Re: Chevron Service Station # 9-1924

Address: 4904 Southfront Road, Livermore, California

Re: **Response to Comments**  
 Chevron Service Station #9-1924  
 4904 Southfront Road  
 Livermore, California  
 Fuel Leak Case No. RO0000477

FIGURE  
**2**

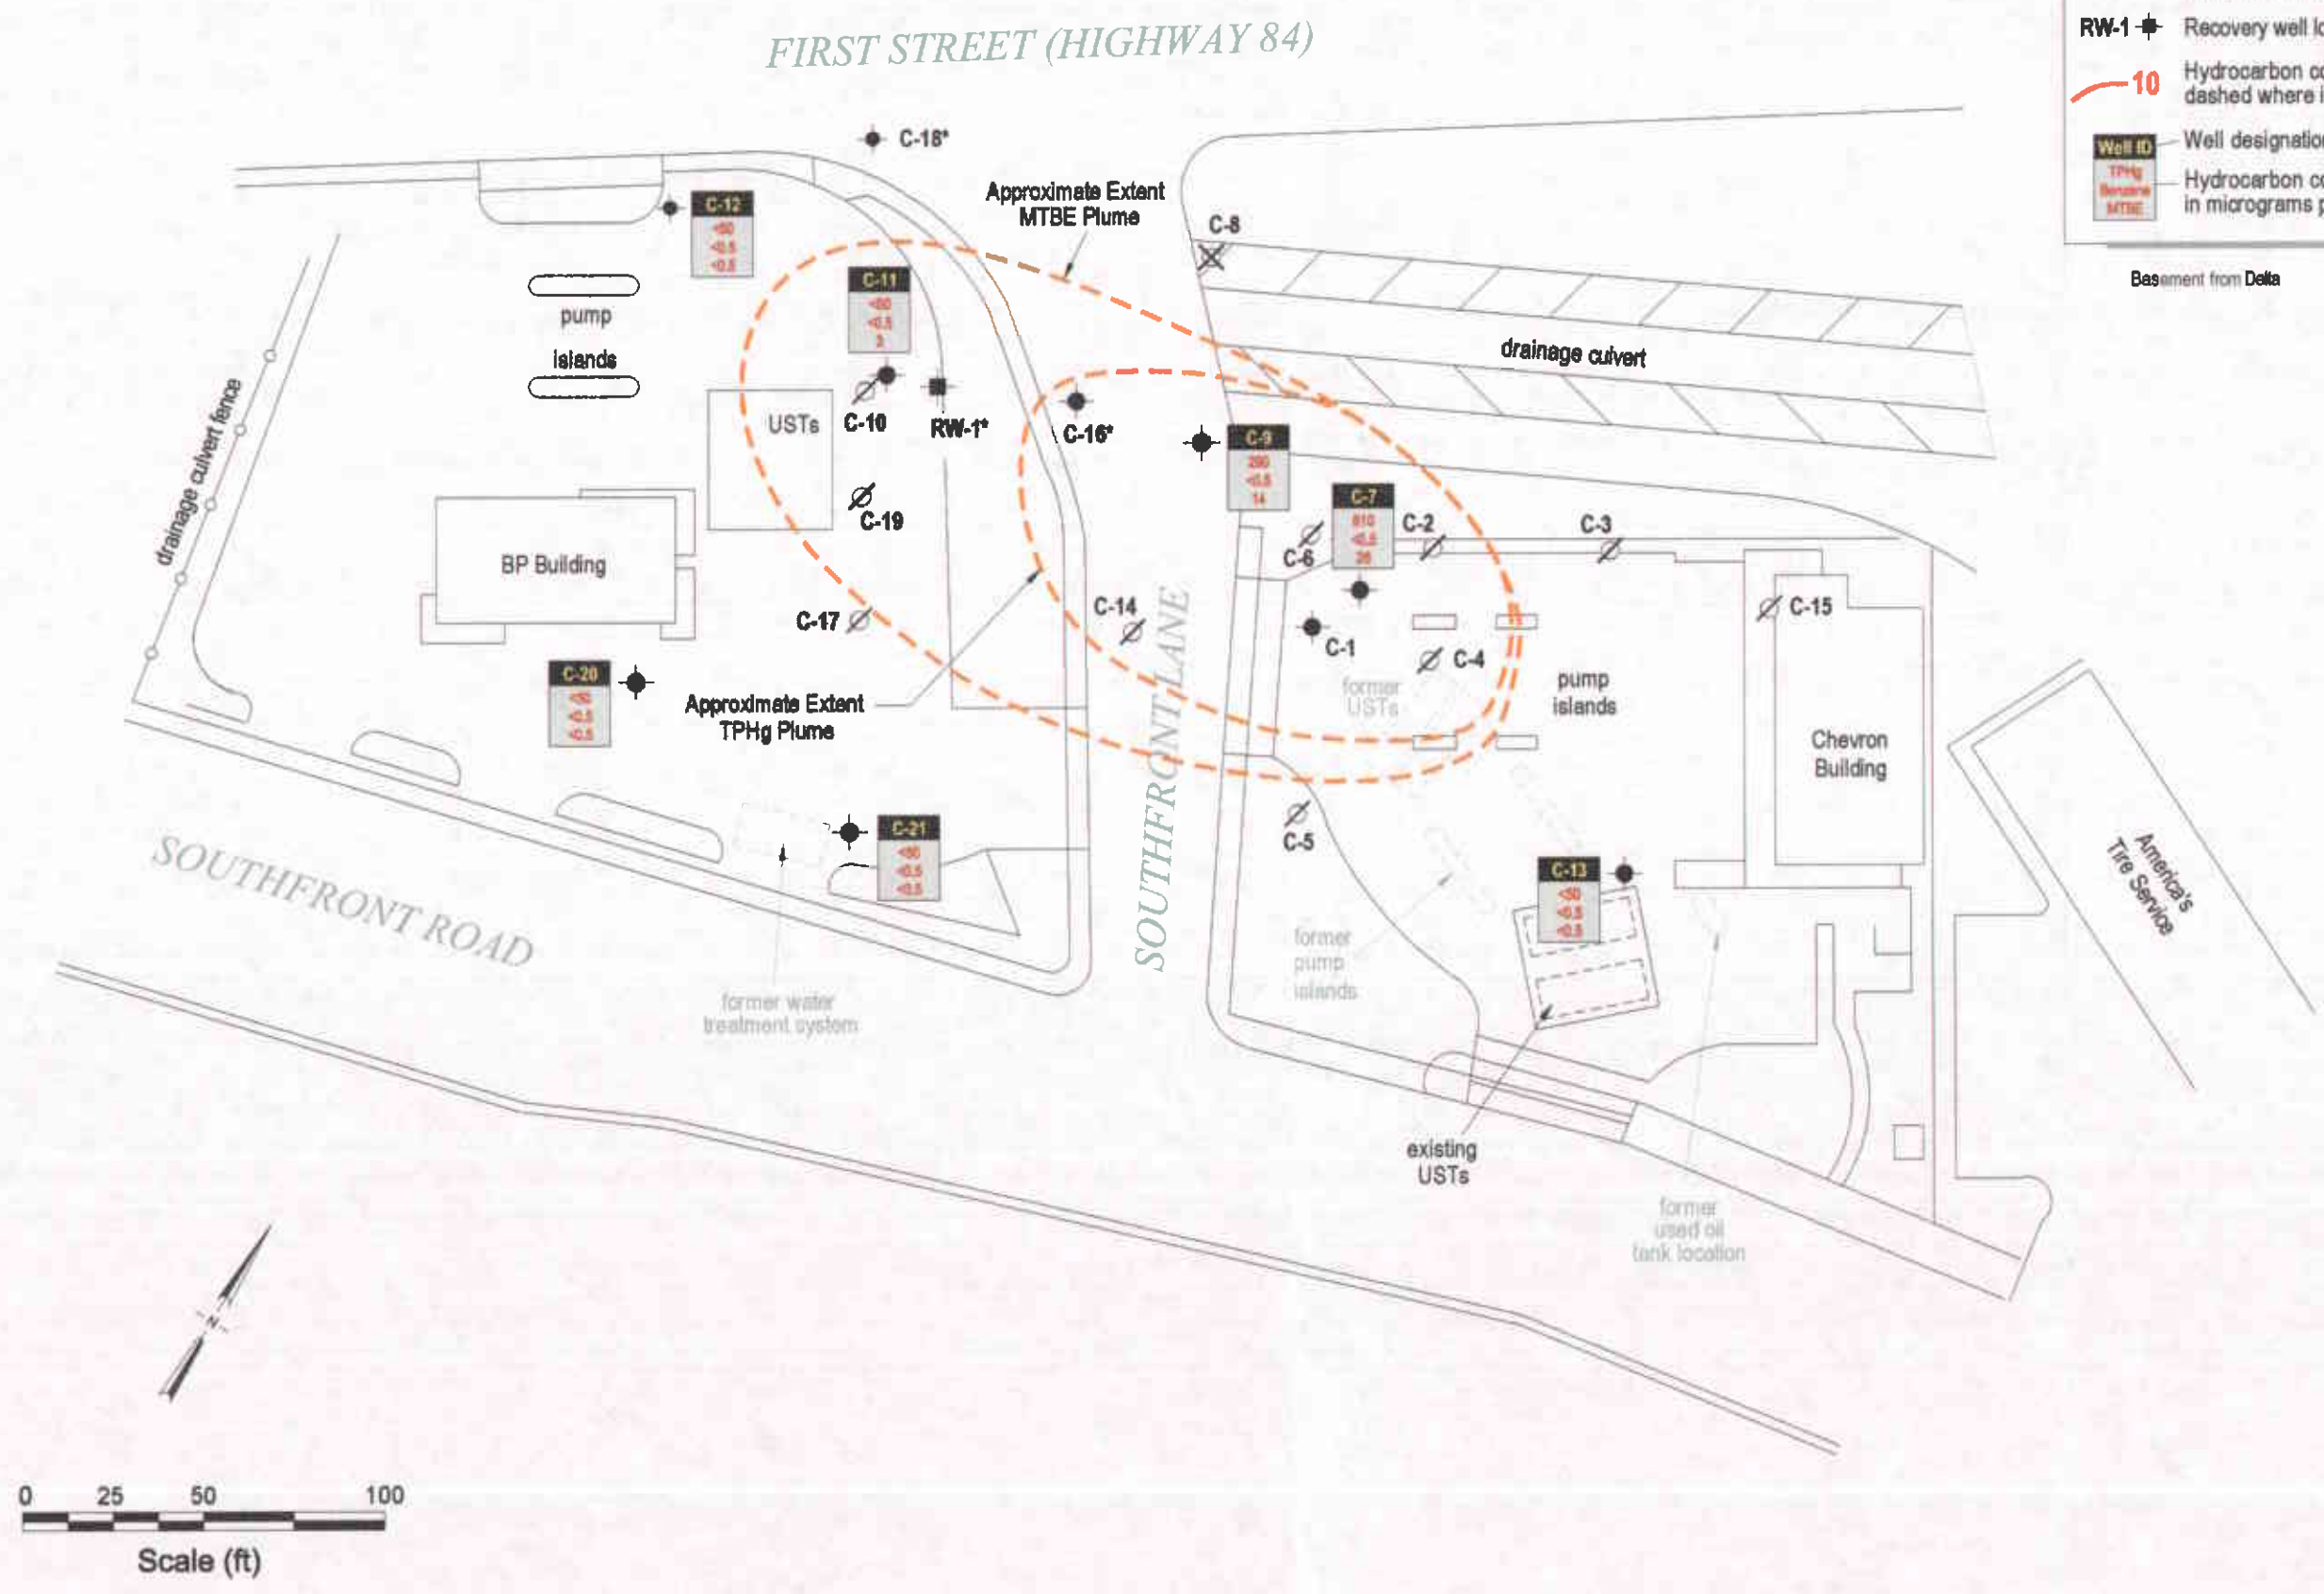
2. **Impact to Lower Water-Bearing Zones.** The Closure Report states that deeper drinking water aquifers are not likely to be impacted by dissolved hydrocarbons at the site. However, no soil or groundwater samples have been collected below 30 feet bgs at the site to confirm that soil and groundwater has not been impacted at greater depths. Please expand upon the discussion of potential impact to lower water-bearing zones using, but not limited to, additional information on the stratigraphy, depth to water-bearing zones, likely vertical gradients, and historic water level fluctuations. Please present regional and site-specific information as necessary to support your discussion. The DWR well search in the May 27, 2004 SCM indicates that a Zone 7 monitoring well is located in close proximity to the site. The Zone 7 monitoring well may be a source of useful information to help address the above items. Please incorporate this information as appropriate in the Response to Comments requested below.

Only recent alluvial deposits of the Upper Aquifer appear present beneath the site. Although there is lateral hydraulic connectivity within the Upper Aquifer between the Mocho I Sub-basin and the water producing Main Basin portion of the Mocho II Sub-basin, lower water-bearing zones of the Lower Aquifer within the Mocho II Sub-basin are located approximately 1.2 miles southwest of the subject site, and vertical hydraulic conductivity between the Upper and Lower Aquifers is impeded by a relatively continuous silty clay aquiclude. Given that the hydrocarbon and MTBE plumes only

extent approximately 150 feet downgradient of the subject site (Figure 2) and appear to be shrinking, potential impact to lower water-bearing zones is unlikely.

**Livermore-Amador Valley Groundwater Basin Map  
and Cross Section**

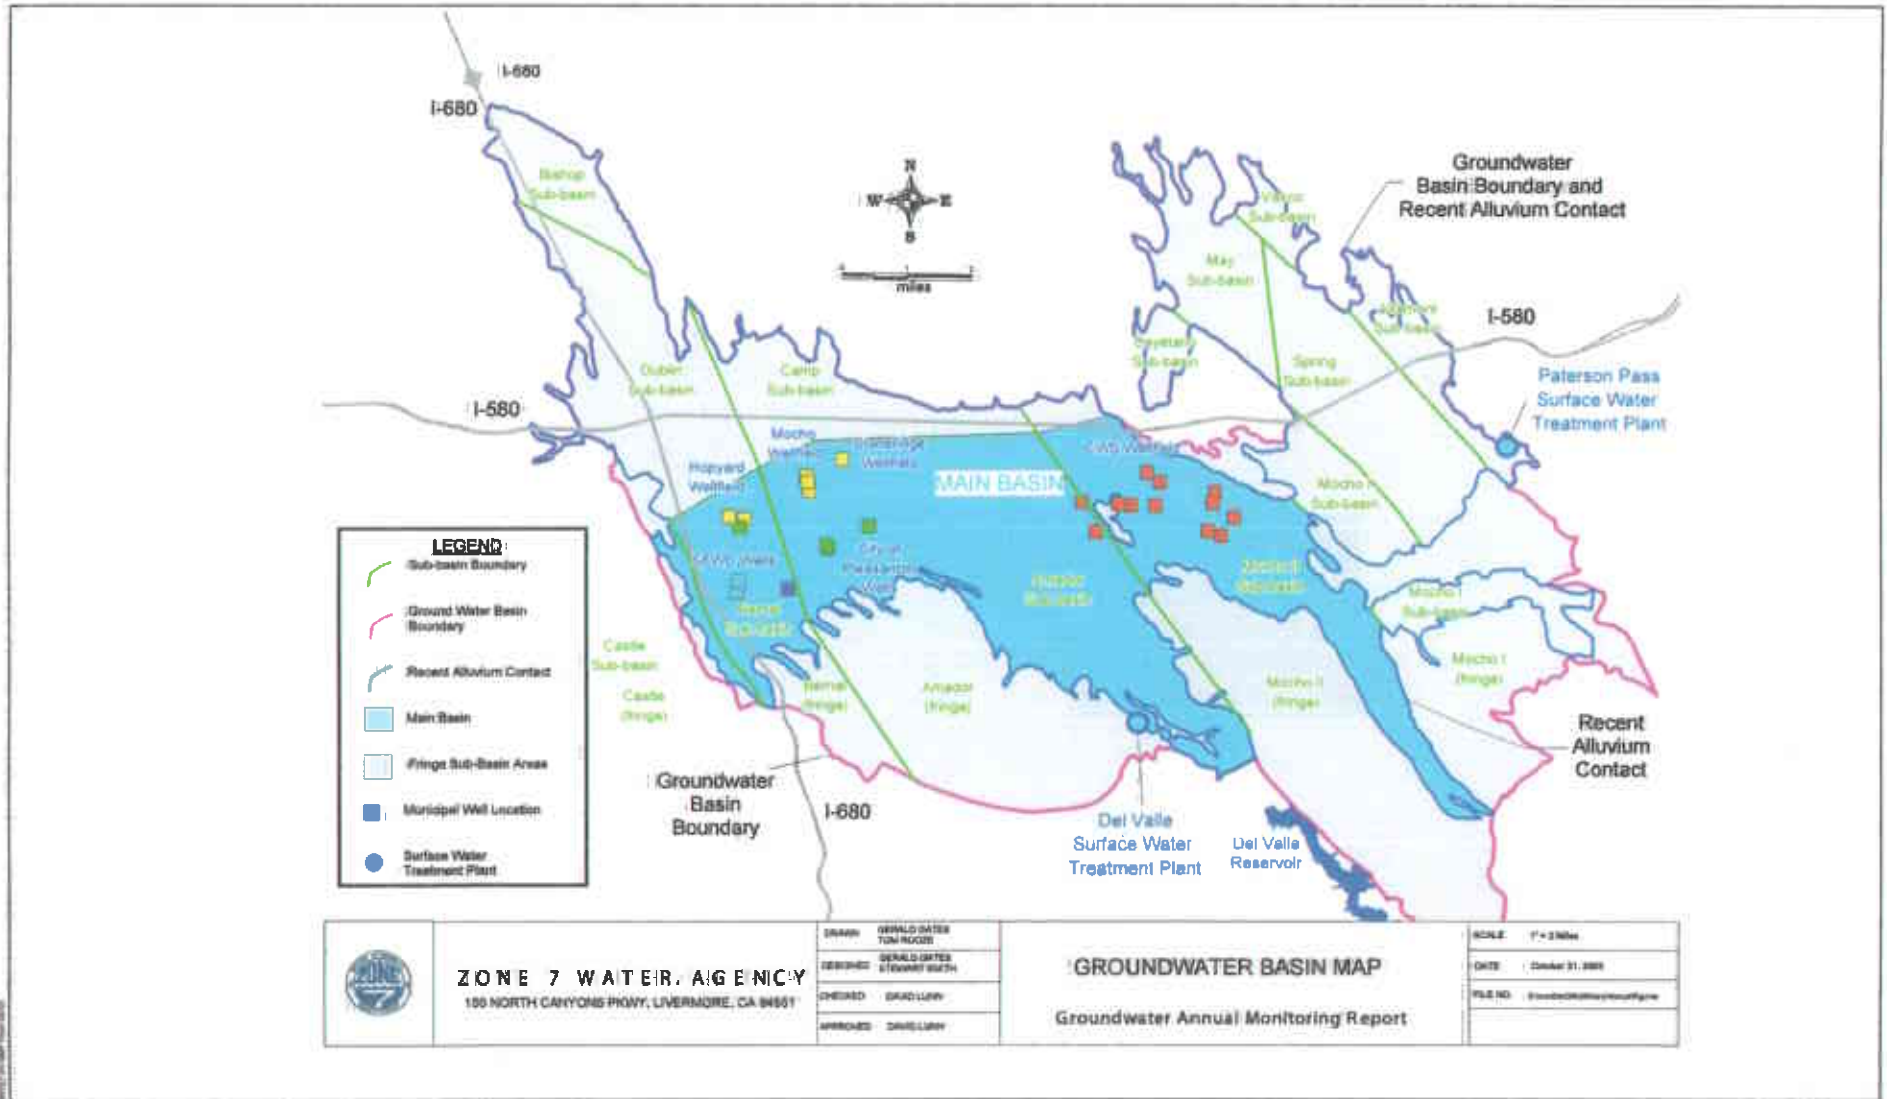
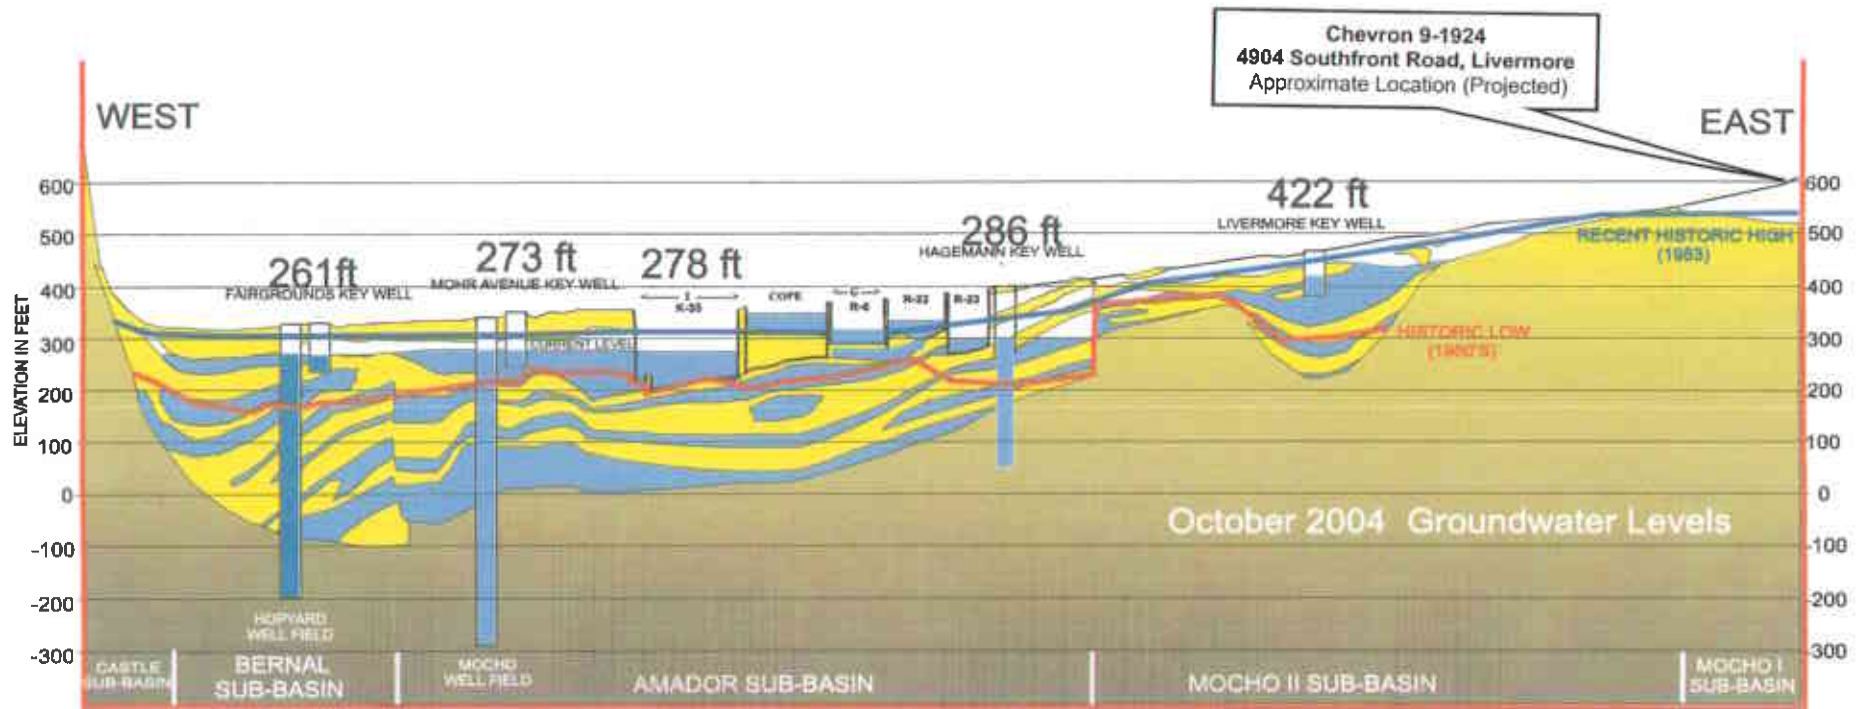
1. **Water Wells near the Site.** The "Site Conceptual Model," (SCM) dated December 8, 2002 describes the results of a California Department of Water Resources (DWR) well search that identified five irrigation wells and one domestic well within 2,000 feet of the site (Table 4). The SCM also indicates that the five irrigation wells and one domestic well were destroyed. No information on the total depth of the wells or well construction is presented. We request that you also obtain well information from Zone 7 Water Agency to confirm that no other water supply wells exist within 2,000 feet of the site and to confirm that the irrigation and domestic wells were destroyed. In addition, we request that well construction information, particularly the depth at which the water supply wells in the area were screened, be presented in order to help assess potential future impacts on groundwater use near the site. Please present this information using maps and tables as necessary in the Response to Comments requested below.

For responses to items 1 and 2, Cambria obtained information published in the September 2005 Livermore-Amador Valley groundwater basin plan (Jones & Stokes, 2005). Attachment B includes maps showing the location of the subject site in relation to Zone 7 water producing wells and main water producing basin, and Section 3 of the groundwater basin plan describing the water resources of the groundwater basin is included in Attachment C.

The nearest Zone 7 water producing well is located approximately 1.5 miles southwest of the site, in the Mocho II Sub-basin (Attachment B). The subject site is located near the
